Merged Document Report

Application No.: PL9174

Description :	
Address :	
Record Type :	PLAT

REPLAT OF:
**PADRE ISLAND, No. 1,
LOT 21R, BLOCK 27**

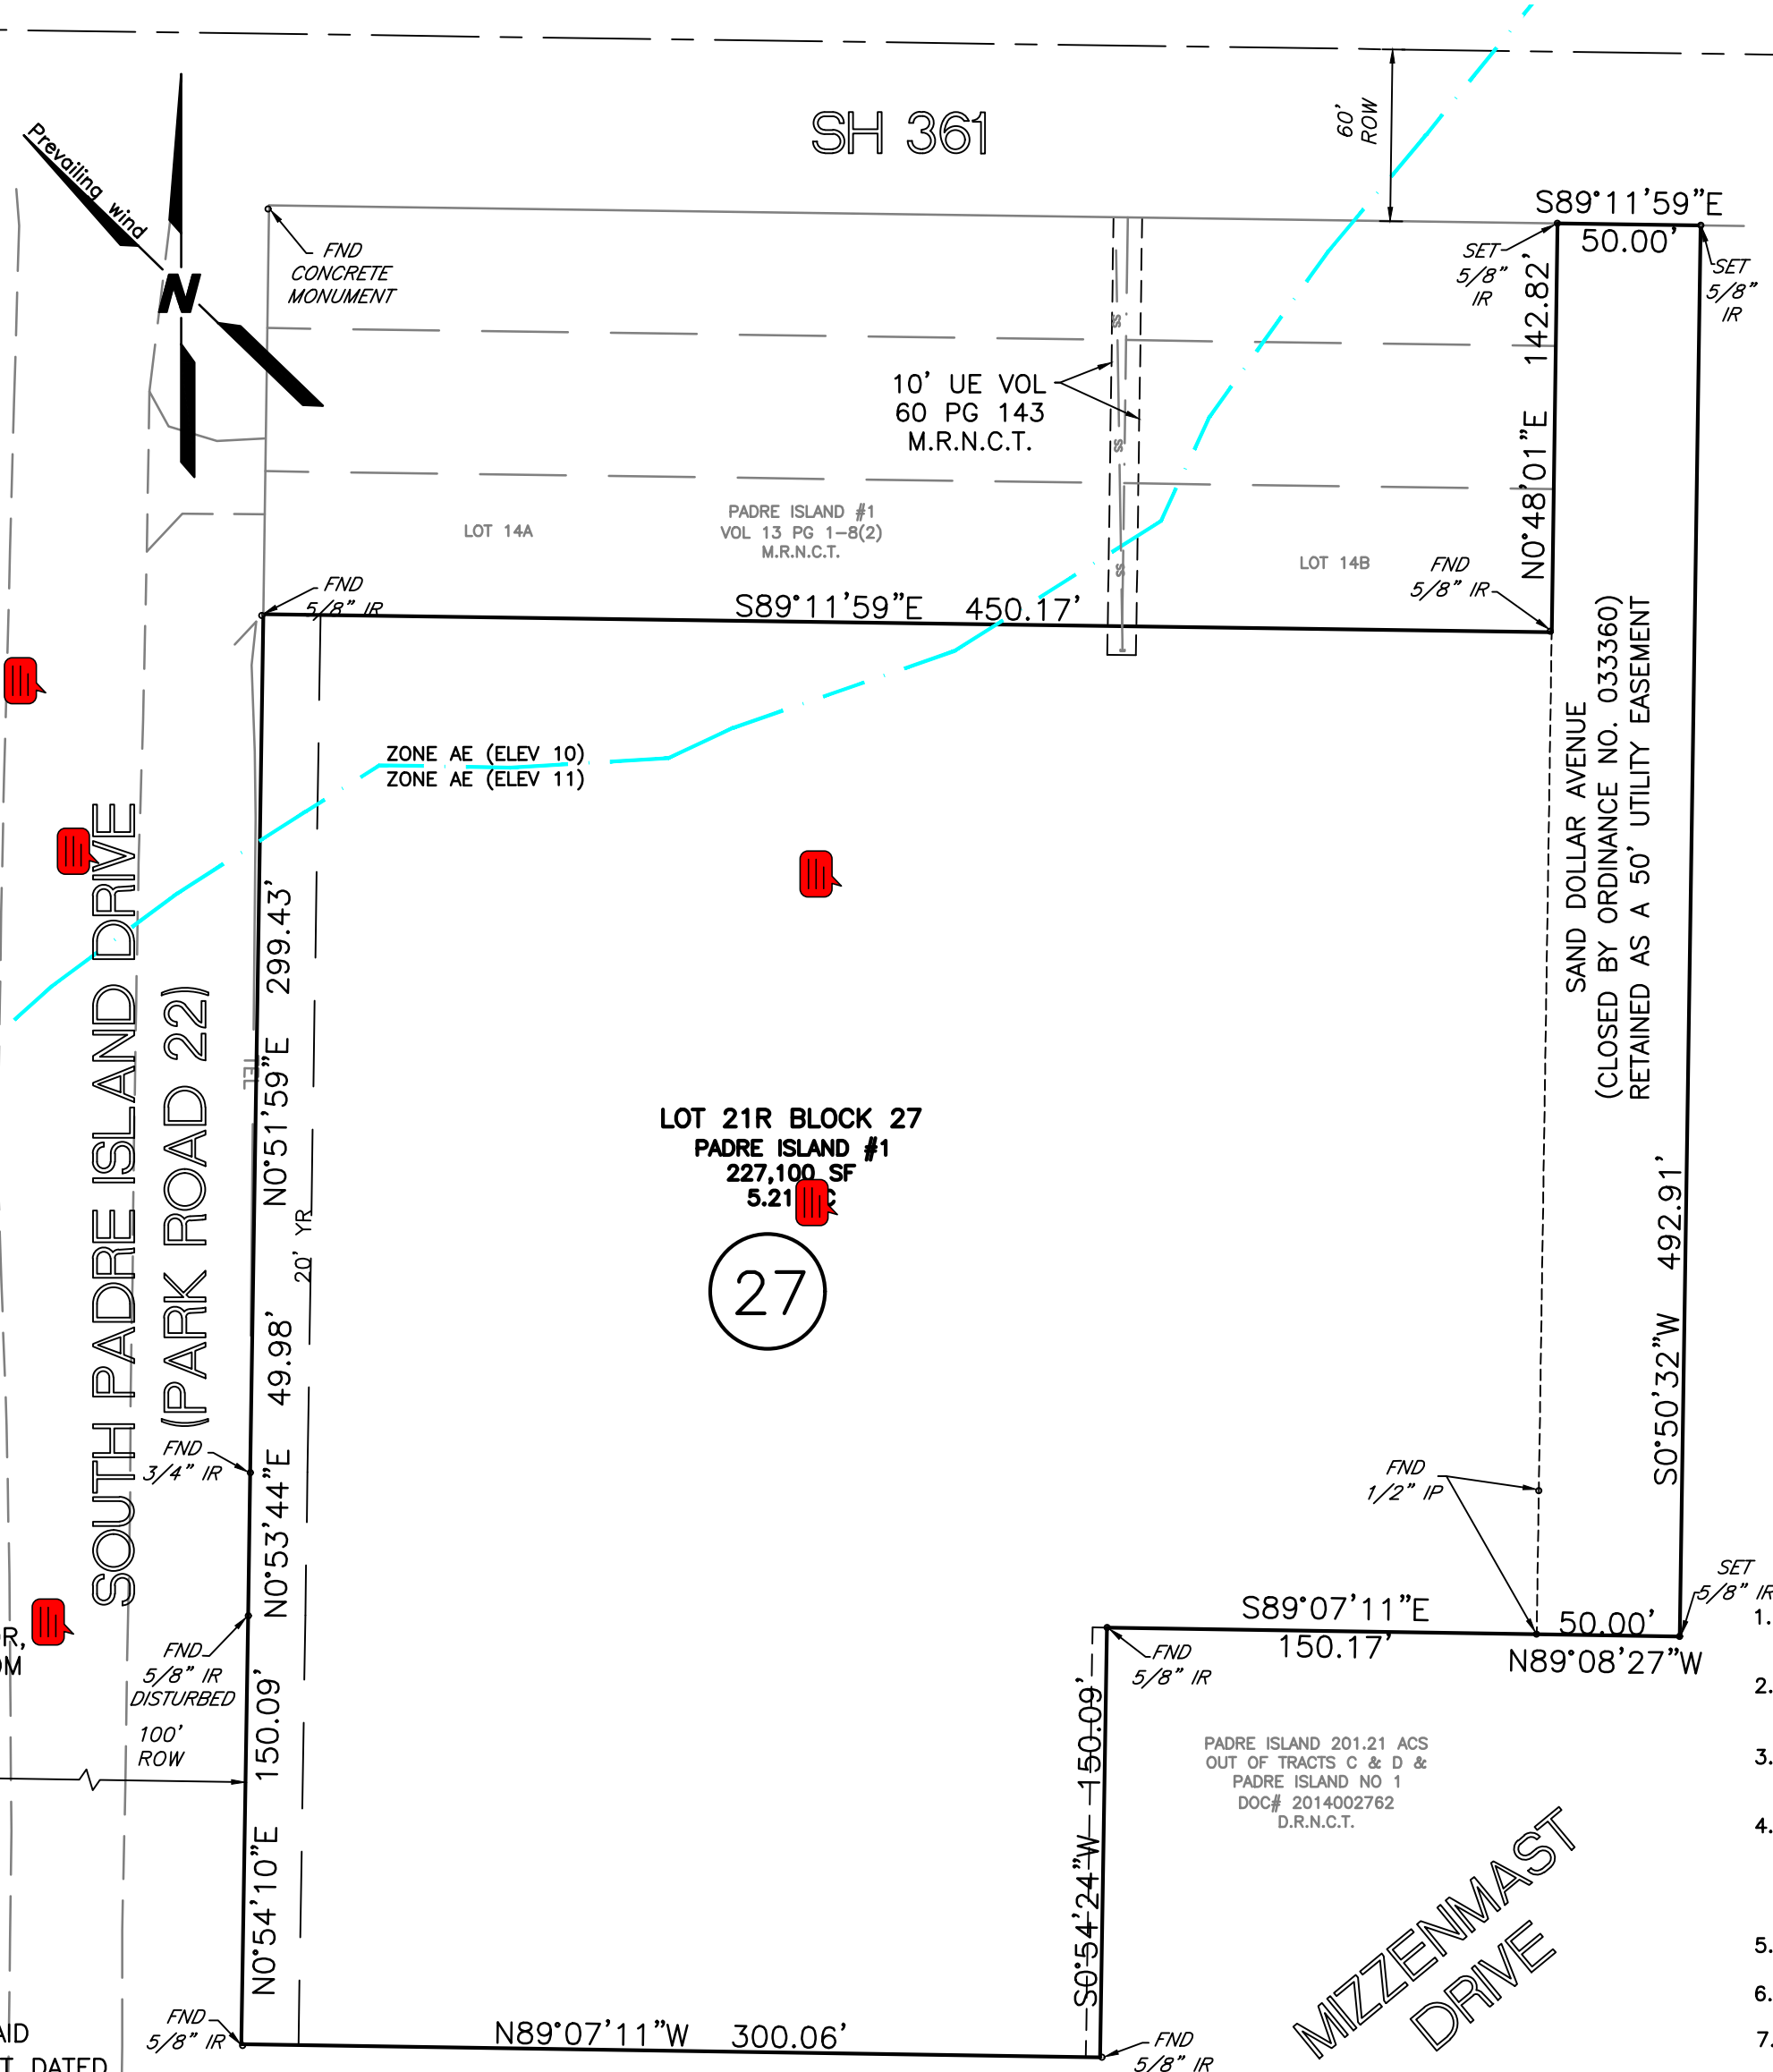
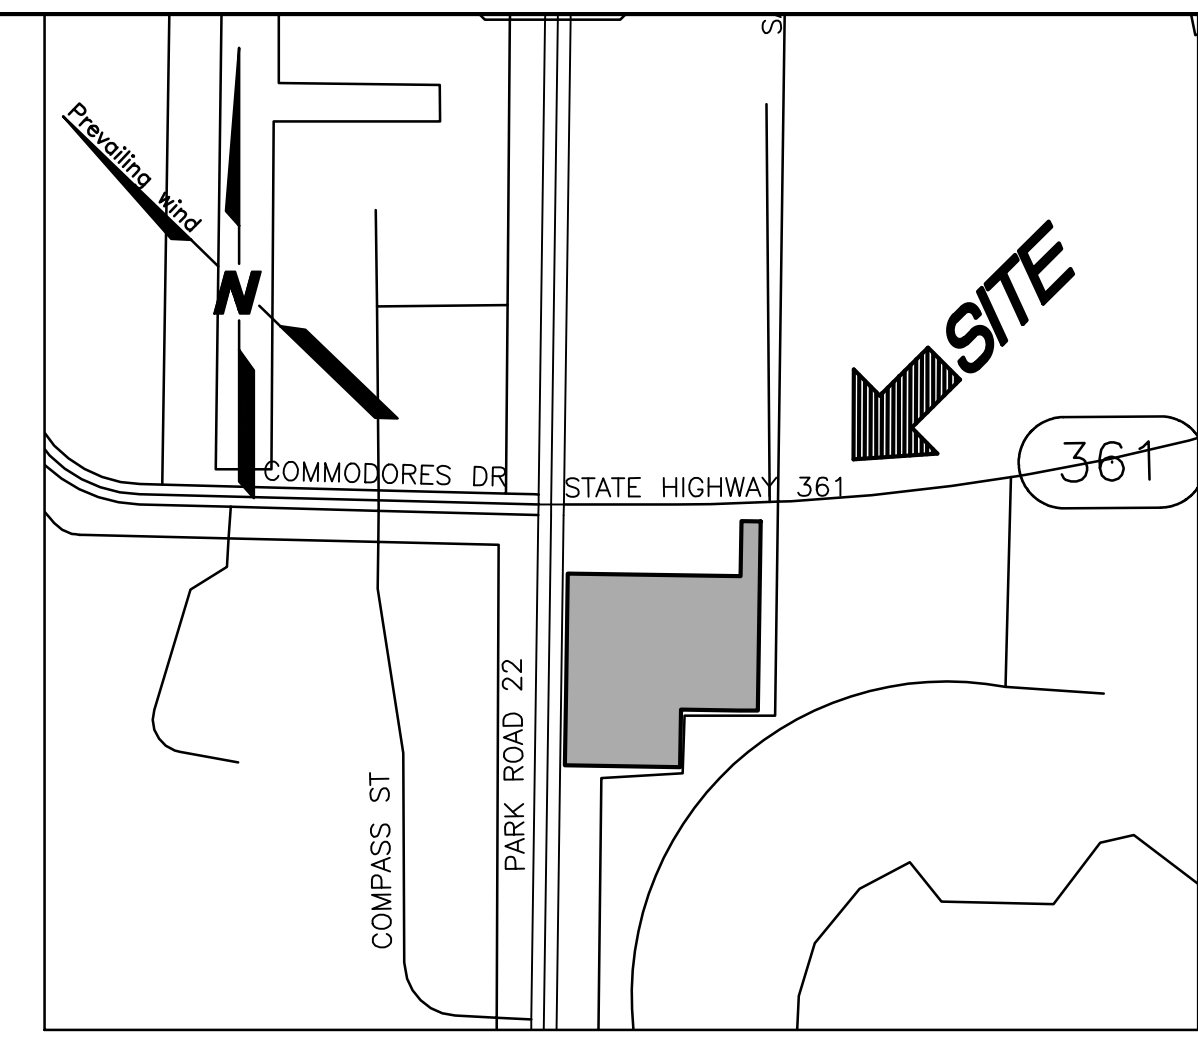
2	P001	Note	Mina Trinidad : DS	Closed	(Informational) Equistar Pipeline will not be involved.	
3	P001	Note	Mina Trinidad : DS	Closed	<p>Update 03/10/26: Plat closes within acceptable engineering standards.</p> <p>GIS: (Ziba A) Plat does not close within acceptable engineering standards.</p>	
5	P001	Note	Mina Trinidad : DS	Closed	(Informational) CCRTA: This plat is located along an existing CCRTA bus route; Route 65 Padre Island Connection but is not immediately adjacent to any existing or foreseeably planned CCRTA bus stops.	
7	P001	Note	Mina Trinidad : DS	Closed	<p>Fire: (Chief Juan Perez) All code reference is based on currently adopted International Fire Code (IFC) 2021 and Corpus Christi Water Distribution Standards</p> <p>Plat: -Commercial Development shall have a fire flow of 1,500 GPM with 20 psi residual Fire hydrant every 300 feet and operational.</p> <p>-If the property use is commercial, the fire flow requirements shall be a minimum of 1,500 GPM at 20 PSI residual. If the property use is industrial, the fire flow requirements shall be a minimum of 3,000 GPM with 20 psi residual. The requirement for each shall be resolved at the Development Service or Building phase of the project.</p>

12	P001	Note	Mina Trinidad : DS	Closed	Depict the block number within a circle for better visibility.	
14	P001	Note	Mina Trinidad : DS	Closed	Remove Michael York signature and add "Cynthia Salazar-Garza Chairperson"	
15	P001	Note	Mina Trinidad : DS	Closed	Change Michael Dice signature to "Director"	
16	P001	Note	Mina Trinidad : DS	Closed	The date within Bria's engineer signature block should be similar to the date within the PC signature block.	
17	P001	Note	Mina Trinidad : DS	Closed	Include square footage within plat boundaries.	
4	U001	Note	Mina Trinidad : DS	Closed	(Informational) Gas Department has no comment.	
9	U001	Note	Mina Trinidad : DS	Closed	(Informational) CCW: Water Water construction is not required for platting (UDC 1.2.1.D & 8.2.6; Water Distribution Standards).

UTILITY SKETCH

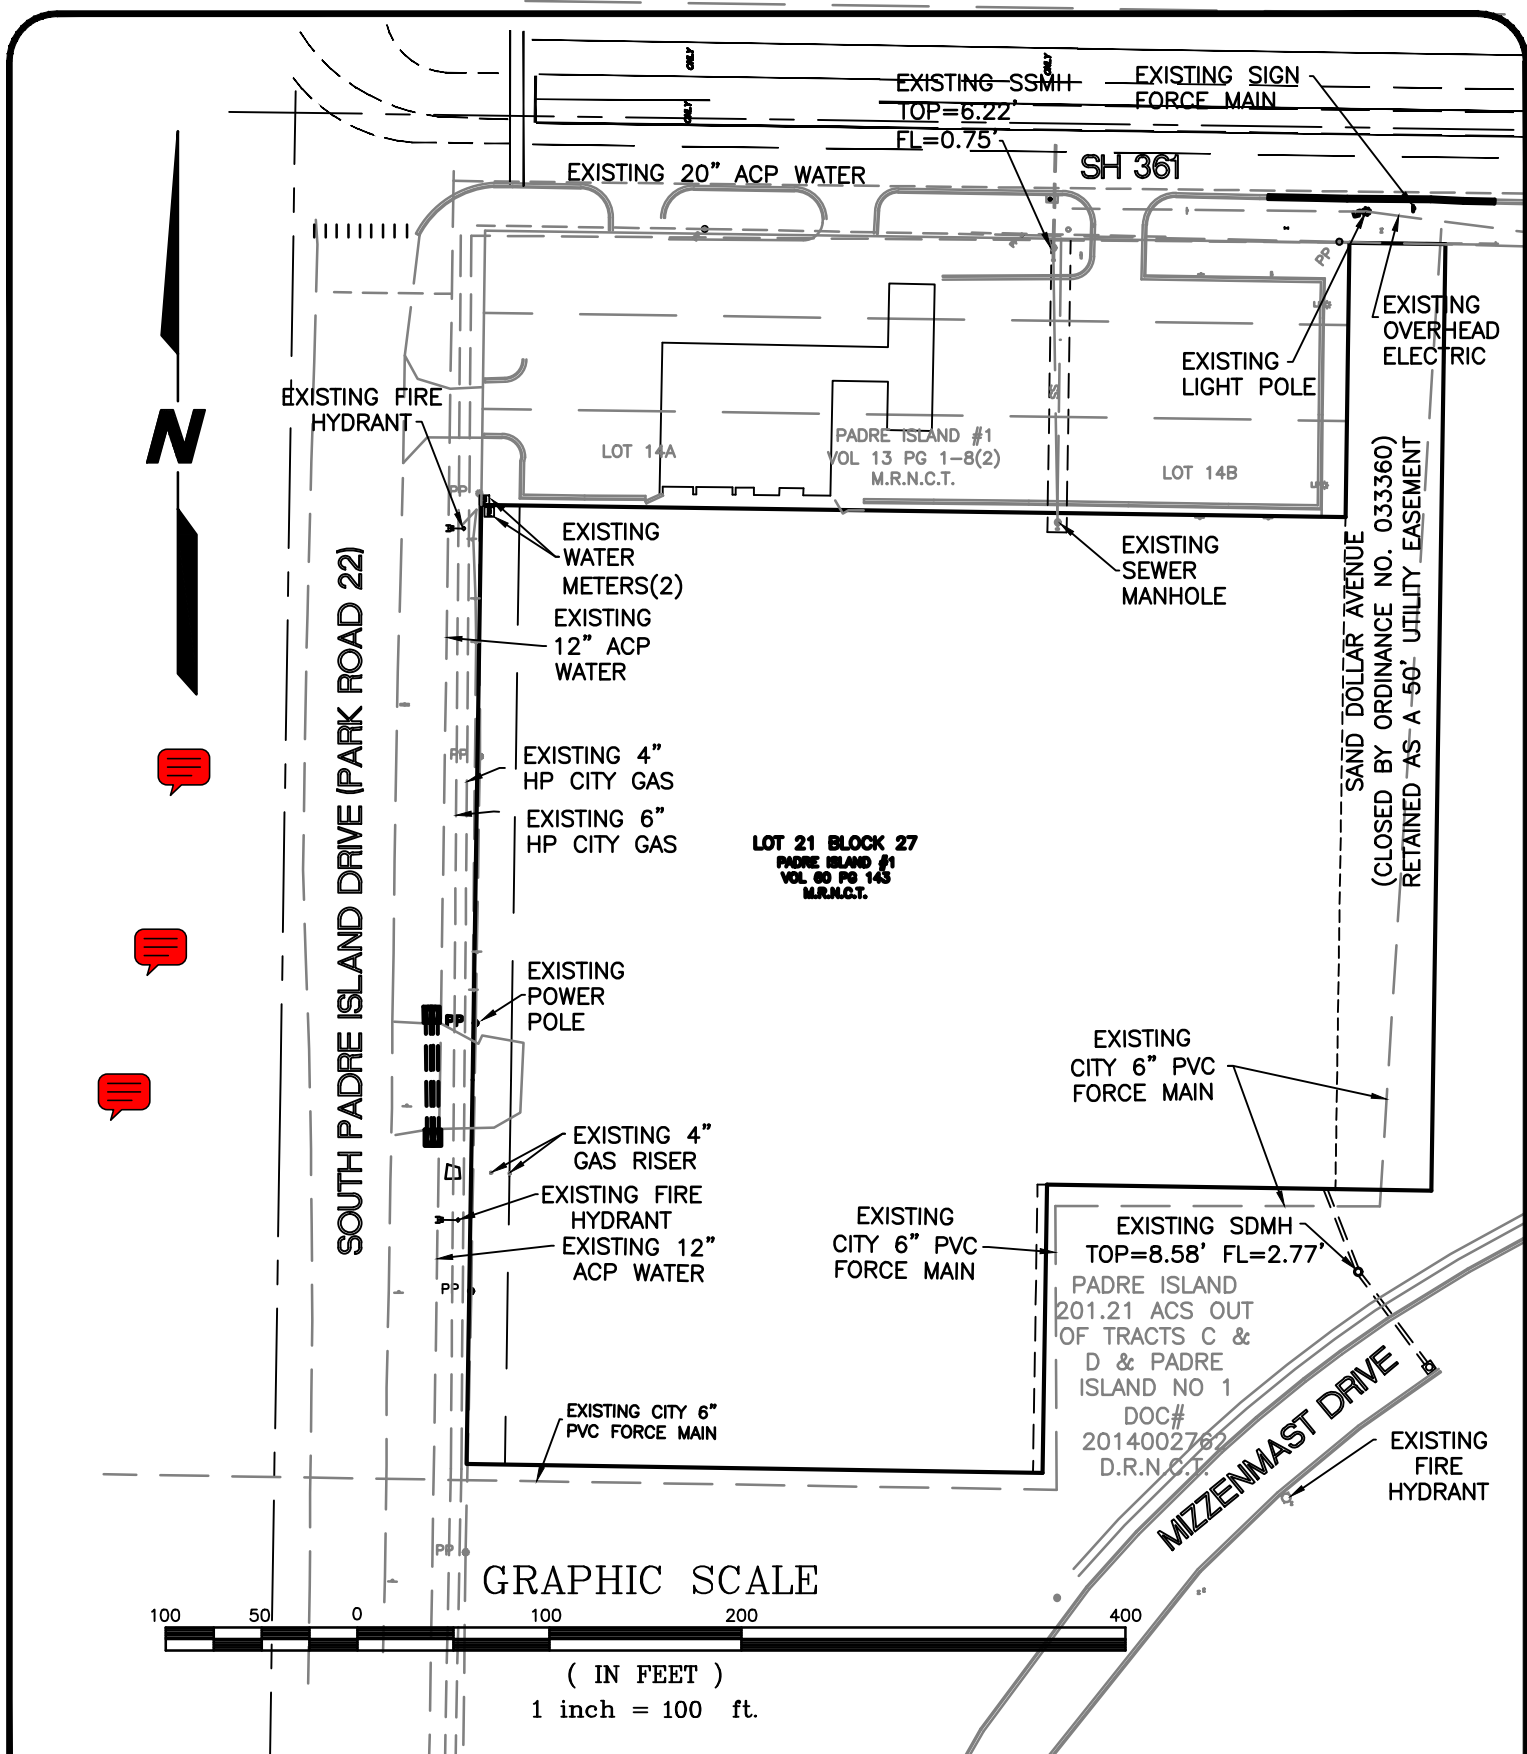
Comment ID	Page Reference	Annotation Type	Author : Department	Status	Review Comments	Applicant Response Comments
10	U001	Note	Mina Trinidad : DS	Closed	CCW: (Fatima Chavez) Wastewater Wastewater construction is required for platting (UDC 1.2.1.D & 8.2.7; Wastewater Collection System Standards).	
6	P001	Note	Bria Whitmire : ENG	Closed	Improvements Required for Recordation, per UDC 8.1.4. A. Streets: No Sidewalks: No Lighting Plan: No B. Water: No Fire hydrants: Not at this time-may be required upon site development C. Wastewater: No D. Stormwater: No E. Public open space: No F. Permanent monument markers: No Please note, improvements required should be constructed to city standards, found in Article 8 and the IDM.
